# UNITED STATES PATENT AND TRADEMARK OFFICE

APPLICATION NO.	FILING DATE	FIRST NAMED INVENTOR	ATTORNEY DOCKET NO.	CONFIRMATION NO.
10/521,387	01/14/2005	Reiner Luttmann	SARTORIUS-12	2344
1218	7590	10/29/2009	EXAMINER	
CASELLA & HESPOS 274 MADISON AVENUE NEW YORK, NY 10016			HOBBS, MICHAEL L	
			ART UNIT	PAPER NUMBER
			1797	
			MAIL DATE	DELIVERY MODE
			10/29/2009	PAPER

<b>Office Action Summary</b>	<b>Application No.</b> 10/521,387	<b>Applicant(s)</b> LUTTMANN ET AL.	
	<b>Examiner</b> MICHAEL HOBBS	<b>Art Unit</b> 1797

## **DETAILED ACTION**

Figure 1: Automated production of recombinant proteins (Cornelissen et al.)

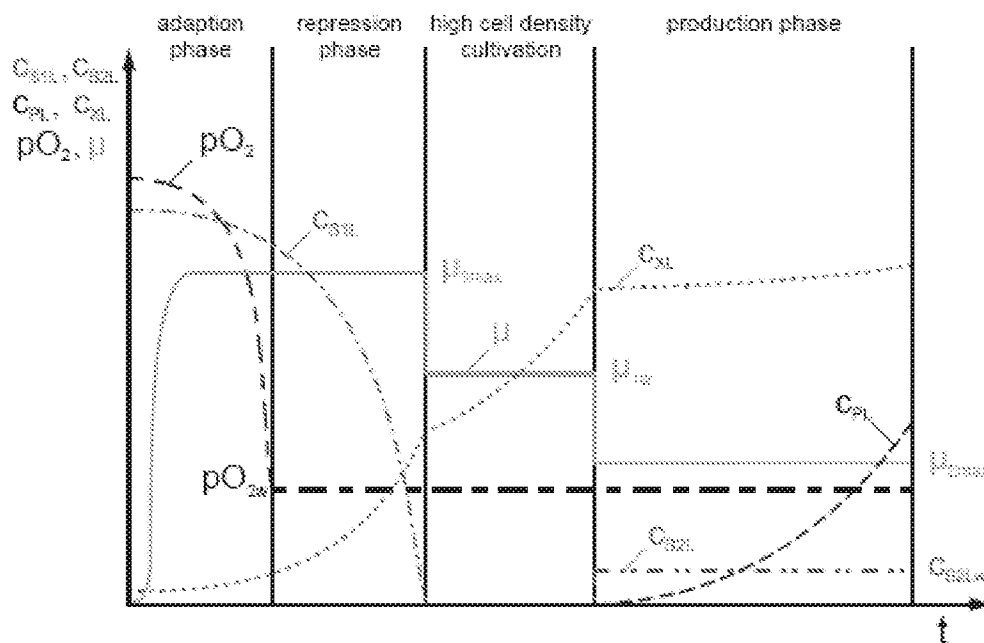
17. For claim 3, Cornelissen teaches the step where the **valuable product** is recombinant proteins (Abstract). For claim 4, Cornelissen does not specify that the process is conducted in a sequential and integrated manner, but does imply that the process steps happen in a specific sequence. Referring to Figure 1 of the OA, each phase of production leads to another phase which strongly implies that the production of recombinant DNA as taught by Cornelissen is sequential. Further, the automation of this process as shown in Figure 4 of Cornelissen shows that each part of the process is integrated or coupled and are part of the whole process (page 6 section 8 paragraph 1). Regarding the method of producing biotechnologically valuable products as in claim 5, Cornelissen teaches that the cells adapt to the medium and that the cells are propagated at a constant growth rate,  $\mu$ , for the batch phase (page 3 sections 3 and 4, Fig. 2) and for claim 6 Cornelissen teaches the step of using an induction substance such as methanol during the production phase (page. 3 section 3 paragraph3) . For claim 7, Cornelissen teaches the step of using a flow diffusion analysis (FDA) to regulate a second feed receptacle (page 3 section 4, Fig. 3). With regards to claim 8, Cornelissen teaches that the product is harvested from the bioreactor by using a cross-flow filtration step (page 1 section 2 paragraph 5), but does not specify that the product is harvested cell-free. However, since the cross-flow filtration step filters out the

21. For claim 15, Cornelissen does not specify that the process is conducted in a continuous and integrated manner, but does imply that the process is continuous and integrated. Referring to Figure 1 of the OA, each phase of production leads to another phase which strongly implies that the production of recombinant DNA as taught by Cornelissen is continuous. Further, the automation of this process as shown in Figure 4 of Cornelissen shows that each part of the process is integrated or coupled with every step and device of the larger process (page 6 section 8 paragraph 1).
